BULLETIN TECHNIQUE 2015 n°03

208 T16

14 janvier 2015

Roulement galet tendeur de courroie accessoire (réf. PS89725A10)

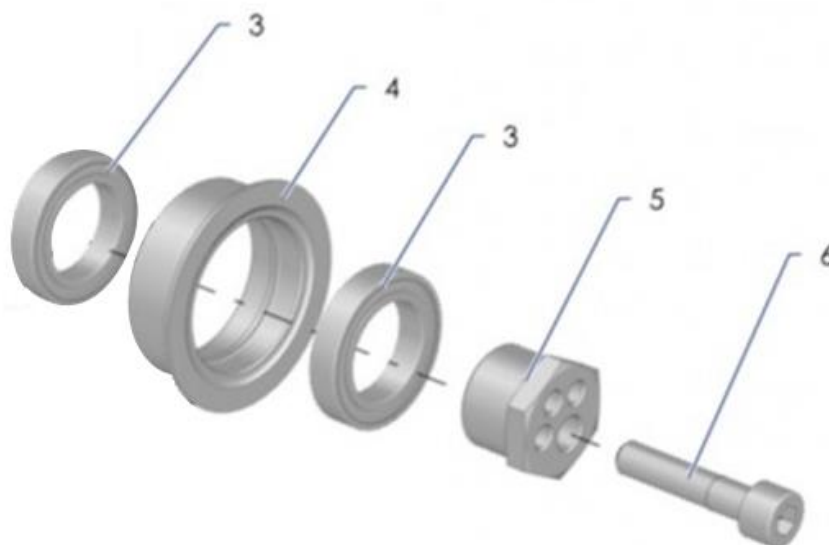
Suite à une erreur d'approvisionnement des roulements de galet tendeur de courroie d'accessoire (repère 3 sur l'image ci-dessous, référence PS89725A10), nous vous prions de bien vouloir contrôler la couleur des bagues d'étanchéité plastique de ces roulements.

En effet, **les roulements conformes ont des bagues d'étanchéité en plastique de couleur verte alors que celles des roulements non conformes sont de couleur noire.**

L'utilisation de ces roulements « noirs » peut entraîner la rupture rapide de la pièce, la perte de la courroie d'accessoire et des dégâts non-négligeables sur votre moteur.

De plus, nous vous informons que la **préconisation de remplacement de ces roulements** de galet est modifiée à **500 kilomètres** d'E.S. et de test au lieu de 1000 kilomètres précédemment, et qu'un contrôle de l'état et du jeu dans le roulement doit être effectué après chaque rallye.

La référence du roulement non-conforme avec bagues plastiques noires est :
SKF 61906-2RS1

La référence du roulement conforme avec bagues plastiques vertes est :
SKF 61906-2RZ

Accessory belt tensioner bearing (part number PS89725A10)

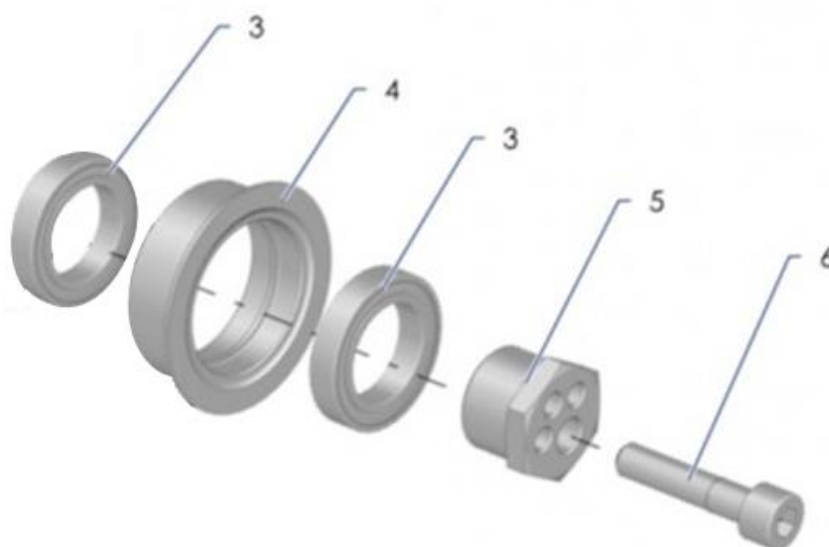
Due to a supply error on the accessory belt tensioner bearing (item 3 on the picture below, part number PS89725A10), we could have provided a wrong batch of bearings. Thus, thank you to check the color of the plastic sealing rings of these bearings.

As a matter of fact, **the correct bearings have green plastic sealing rings while those which are not correct have black plastic sealing rings.**

The use of these "black" bearings can lead to the fast breaking of the parts, the loss of the accessory belt and then damages the engine.

Furthermore, we inform you that the **replacement mileage recommendation** of these bearings is now **500 kilometers** of stage and tests (instead of 1000 km previously). And we recommend you to check your bearings after every rally.

Part number of the
wrong bearing with
black plastic sealing
ring:
SKF 61906-2RS1

Part number of the
good bearing with
green plastic sealing
ring:
SKF 61906-2RZ
